SPRINGDALE SOLAR FARM

Further Request for Information (RFI) Report

Author Steven Reid
Date 1st October 2020
Ref 04317-1602908

2.1 RFI & proponent response

Figure 1 Site Map and receivers

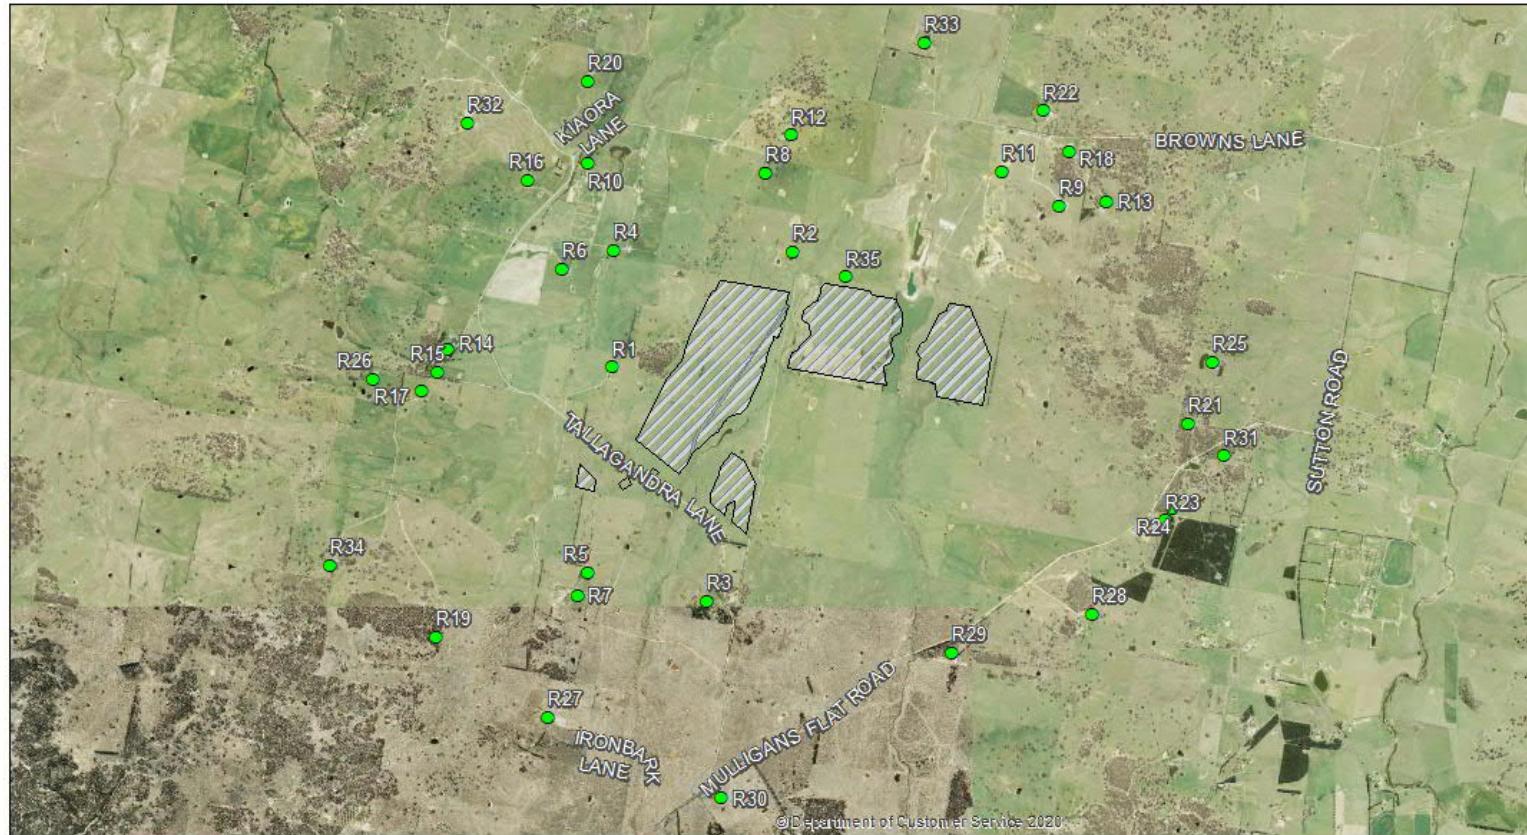
DPIE RFI	Proponent Response
Assessment of noise and visual impacts on the newly erected building/dwelling located to the north of the project, as well as evidence of consultation undertaken with the landowner;	<p>The proponent has met with the current owner of the new property located near the project's northern boundary. We have assigned this receiver with the next 'R' number from the noise assessment; R35. The noise assessment carried out by AECOM, as part of the original EIS, did not include this noise receiver for the obvious reason, it did not exist. The land on which R35 is located has since been subdivided by the former landowner and sold to a new owner, during the period the Springdale Solar Farm has been live in the State Significant Development process. All relevant information on the project's layout and noise impacts have been available to the general public.</p> <p>The proponent has updated the noise assessment with an addendum report See Annexure A. A different inverter and revised inverter location was adopted to mitigate the potential noise impacts at R35. The noise threshold of 35bd(A) is no longer exceeded for operational noise.</p>

- New inverters and associated sound power level information
- Updated inverter locations
- Additional residential receiver located at 42 Tintinhull Road, Sutton (R35 in Figure 1 below).

VISUAL RECEPTOR VIEWSHED

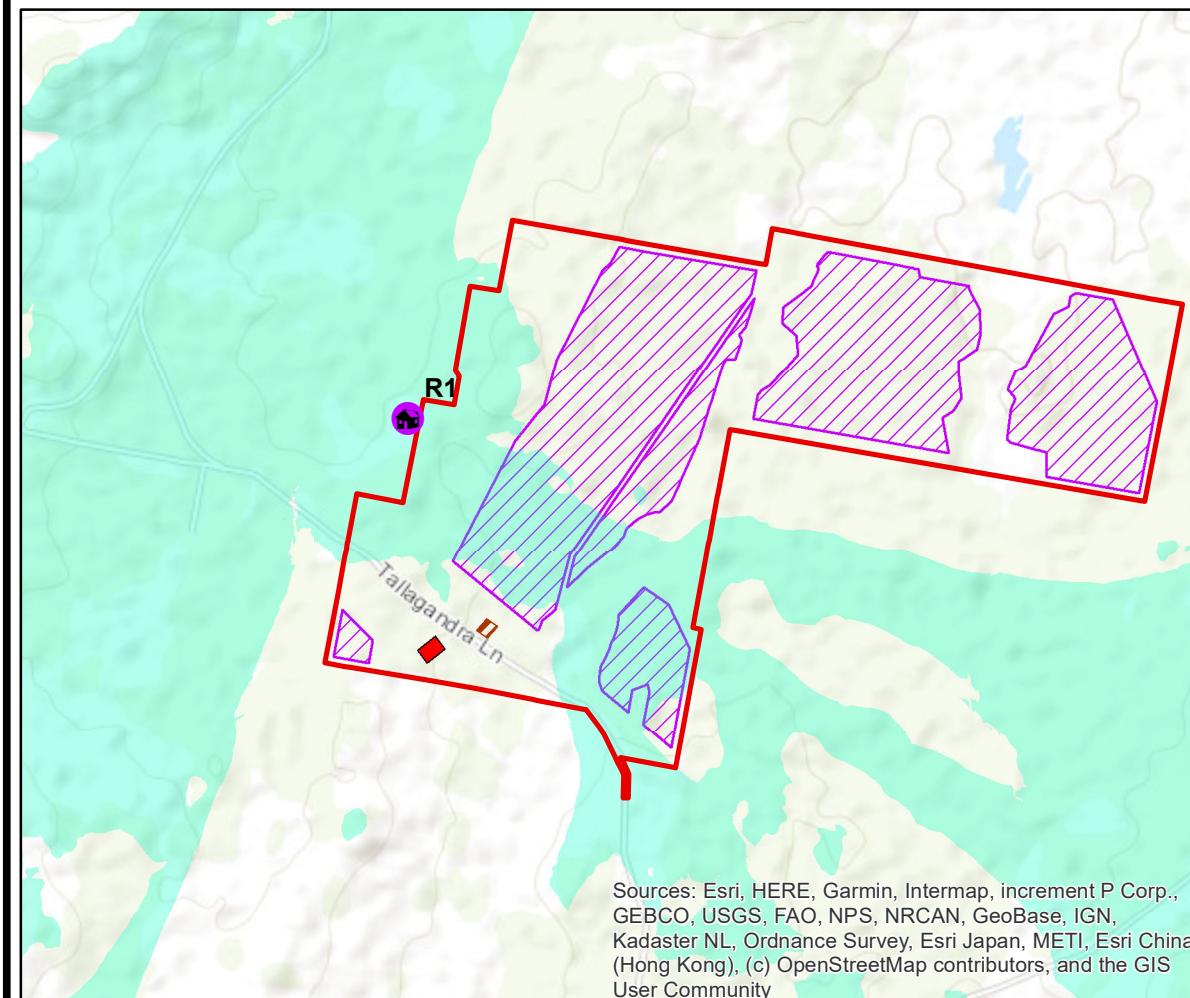
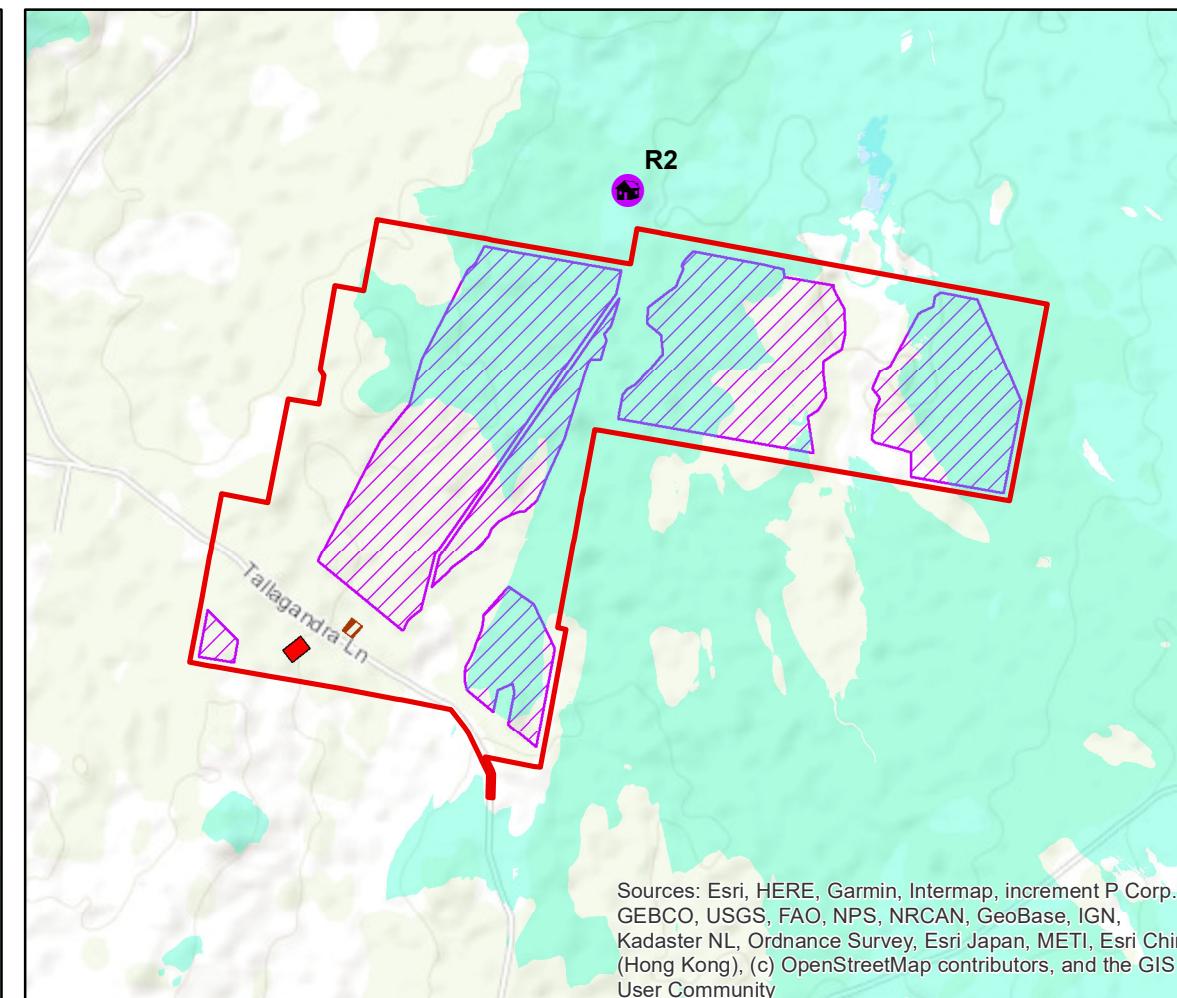
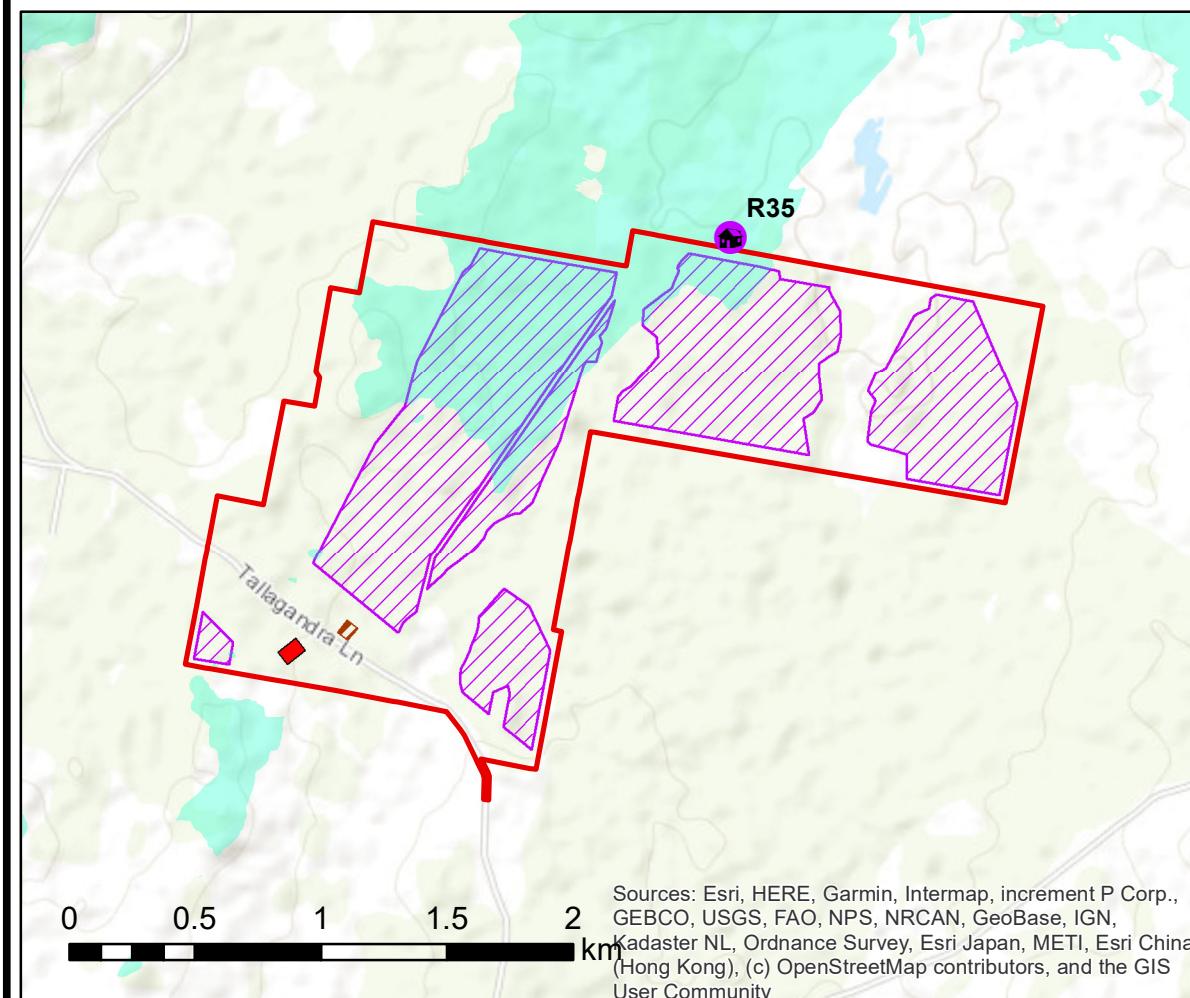
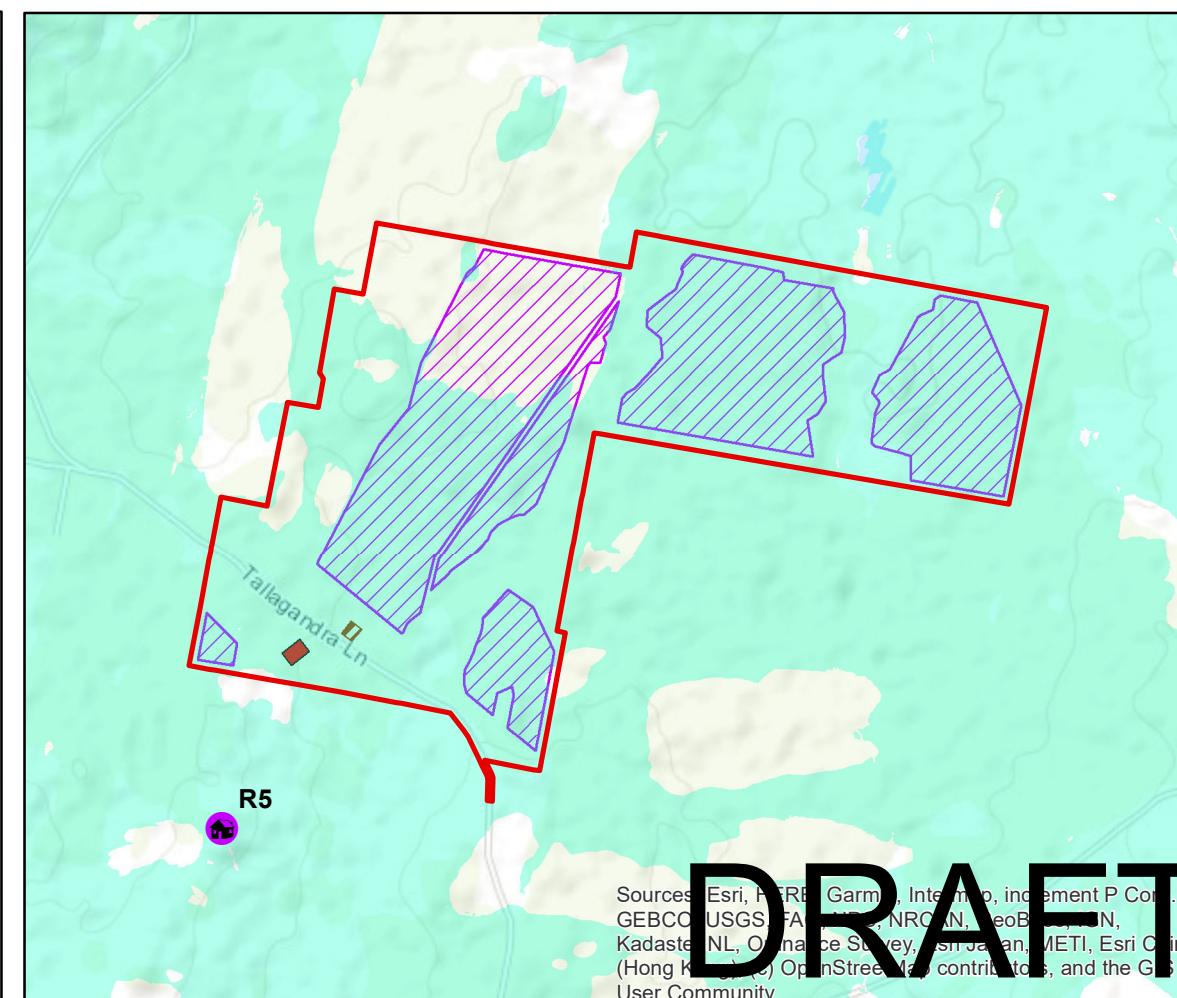
<p>Provide viewsheds from R1, R2, R5 and new dwelling, and confirmation that the Visual Envelope Map in the LVIA is modelled based on topography alone, and not taking intervening vegetation into consideration;</p>	<p>AECOM have confirmed that Figure 2 (Visual envelope map) within the Landscape and Visual Addendum is a zone of theoretical visibility (ZTV) of the project taken at 1.7 metre eye height, with a 2 km range from the perimeter of the solar farm applied. That is, areas that are not shaded on the map are either outside the 2 km buffer or have their view of the solar farm obstructed by the natural topography (from an eye height of 1.7 m). Screening by intervening vegetation was not considered when preparing this map.</p> <p>Viewsheds have been provided for all 4 requested receptors and are included at Annexure B</p>
<p>Updates to the Main Constraints map:</p>	
<p>Label residences as per Noise Impact Assessment numbering (eg Gillett is R1, Hassall is R2 etc);</p>	<p>Completed, see revised Constraints plan at Annexure C.</p>

CONSTRAINTS AND LAYOUT PLAN - AMENDMENTS

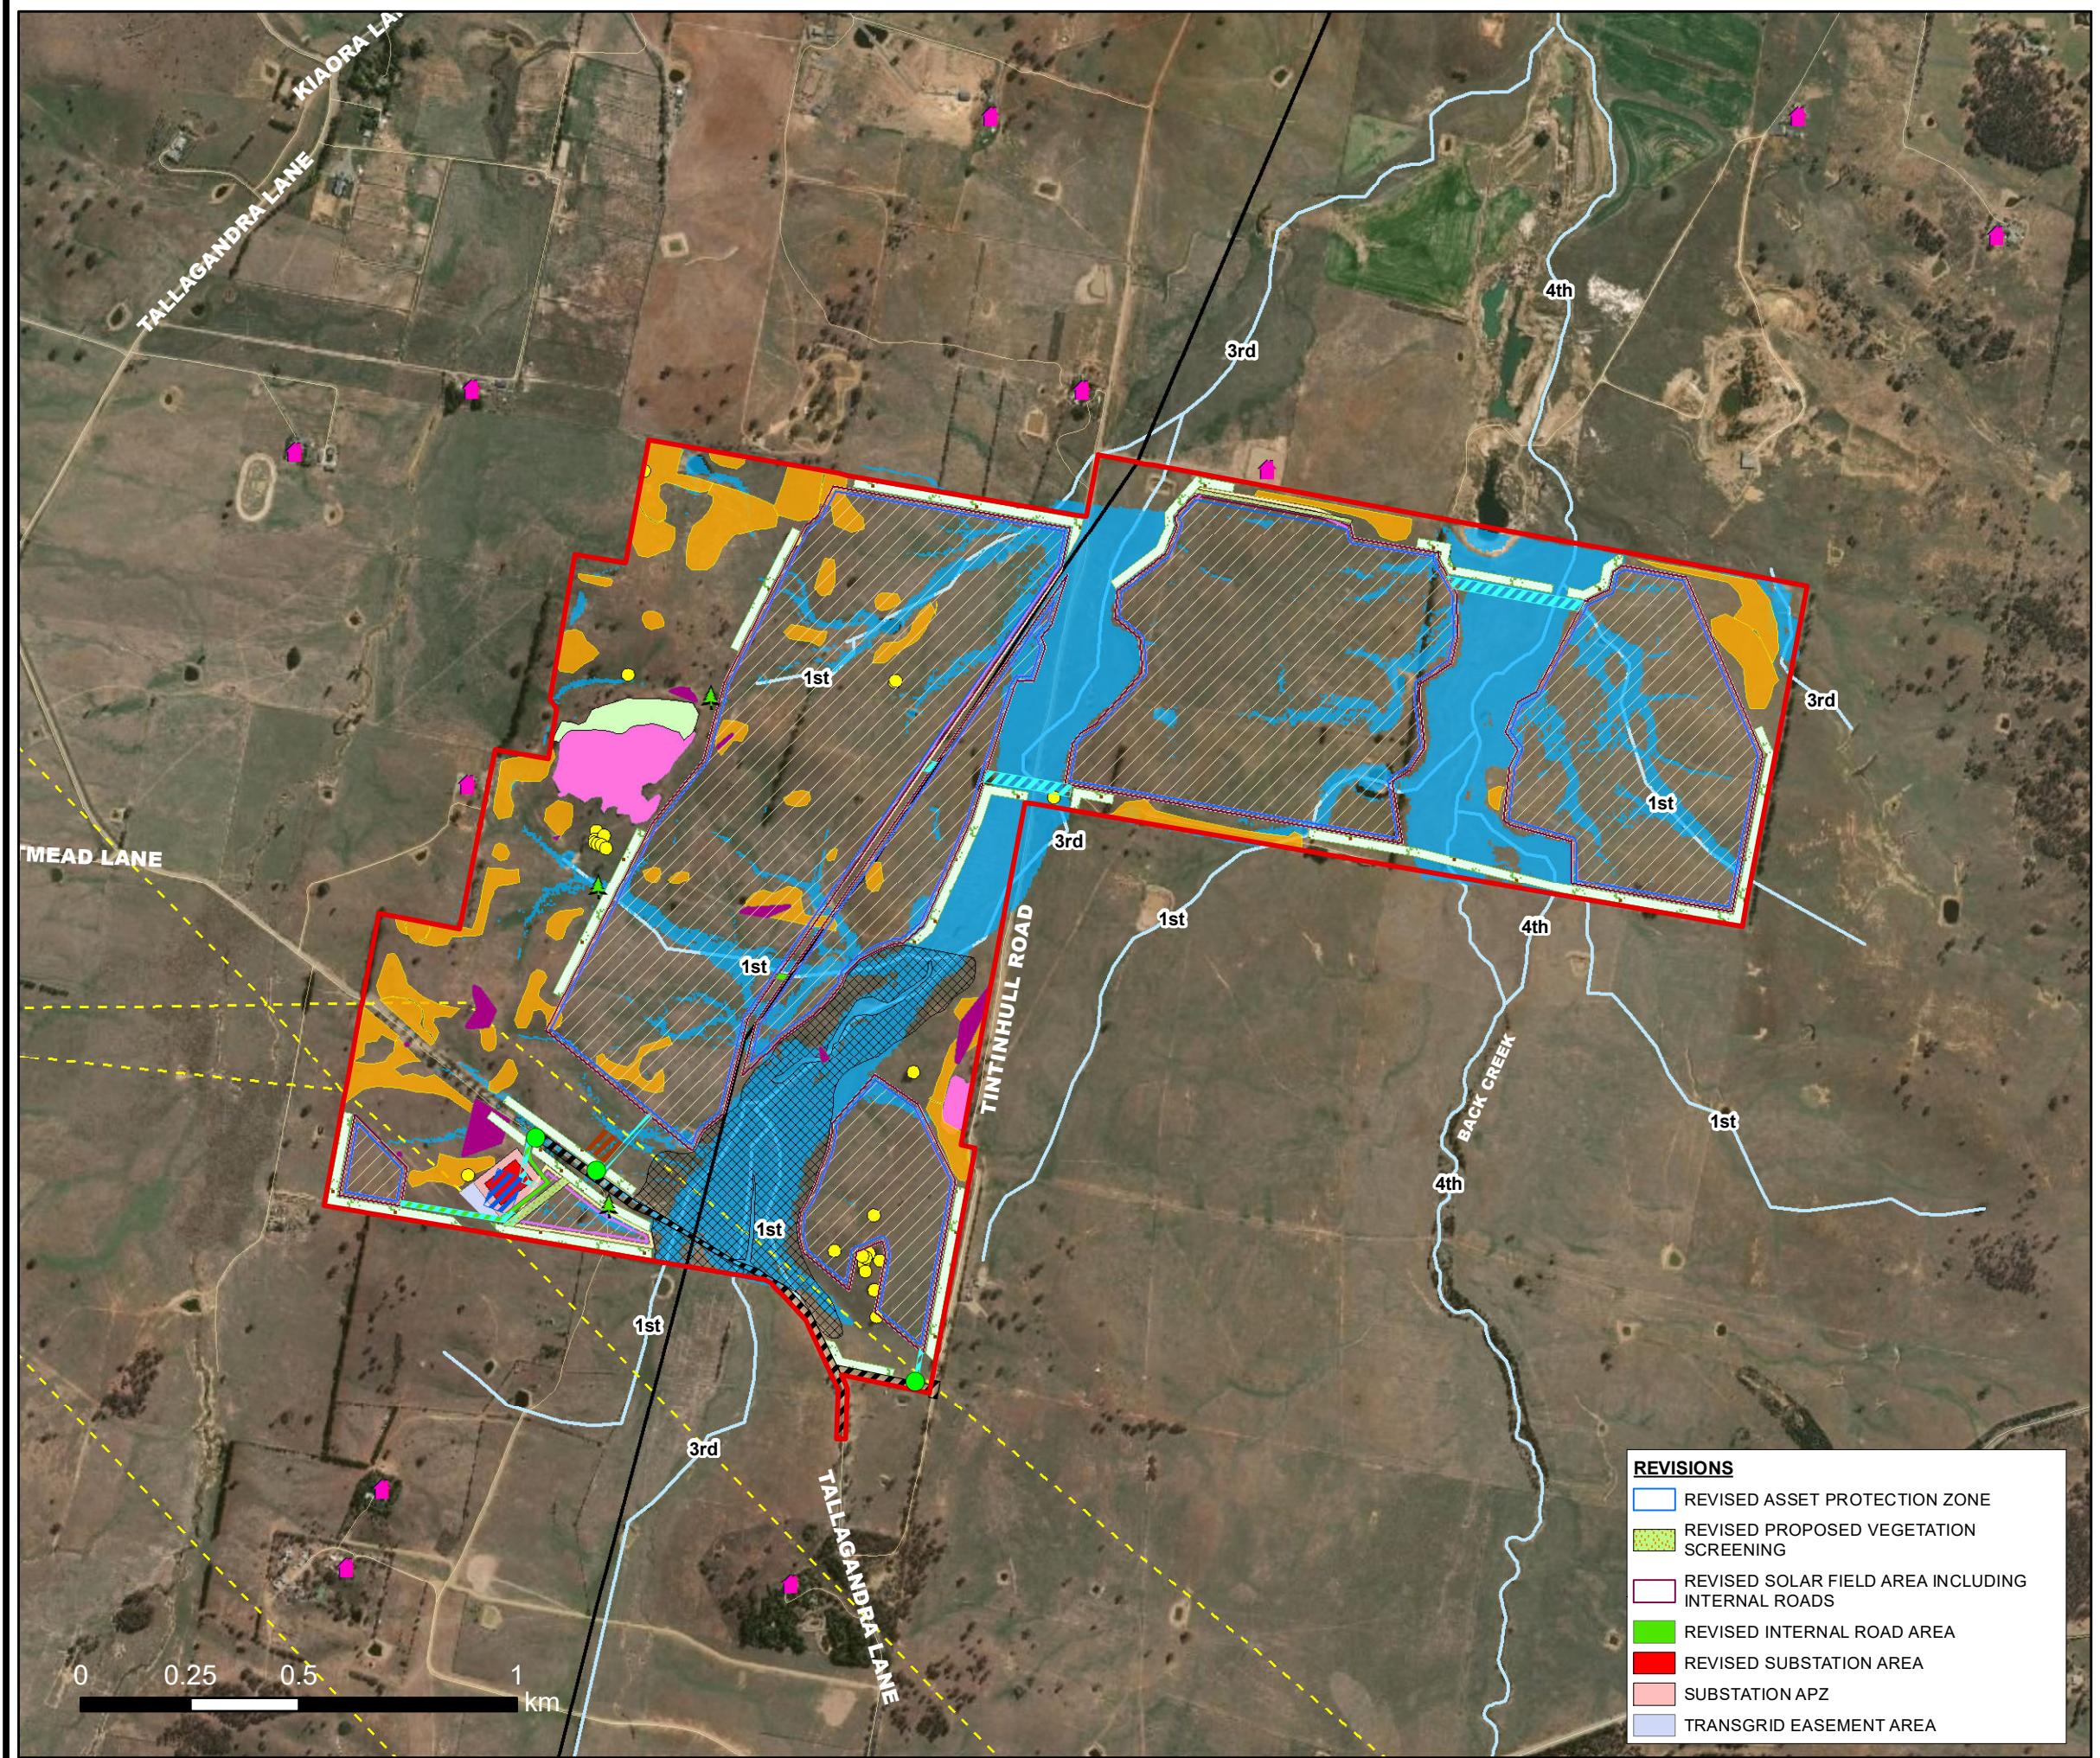
<p>Add security fencing layer;</p>	<p>Completed, see revised Constraints plan at Annexure C.</p>
<p>Remove 1 in 100 year flood profile layer;</p>	<p>Completed, see revised Constraints plan at Annexure C.</p>
<p>Correct the stream orders and confirm adequate buffer distance on the map (can be done via a text box if easier than in the Legend): Back Creek is 4th order stream; and the unnamed creek is 3rd order stream;</p>	<p>Completed, see revised Constraints plan at Annexure C. The amended stream orders is consistent with Water Management (General) Regulation 2018 Hydro Line spatial data, which is used determine the Strahler stream order.</p> <p>The Project has been developed with a view to maintaining appropriate buffers to all relevant environmental constraints, including waterways. It is noted that, as the Project is SSD, the requirement for an activity approval under section 91 of the Water Management Act 2000 does not apply. This is by virtue of section 4.41 of the Environmental Planning and Assessment Act 1979, which specifies certain authorisations which do not apply to SSD. Following this the Natural Resources Access Regulator's Guidelines for controlled activities on waterfront land also does not apply. Despite this, the proponent has worked to avoid sensitive riparian areas, particularly those associated with potential threatened species habitat, such as Striped Legless Lizard Habitat within the southern portion of the site.</p>

- REVISED ASSET PROTECTION ZONE
- REVISED PROPOSED VEGETATION SCREENING
- REVISED SOLAR FIELD AREA INCLUDING INTERNAL ROADS
- REVISED INTERNAL ROAD AREA
- REVISED SUBSTATION AREA
- SUBSTATION APZ
- TRANSGRID EASEMENT AREA
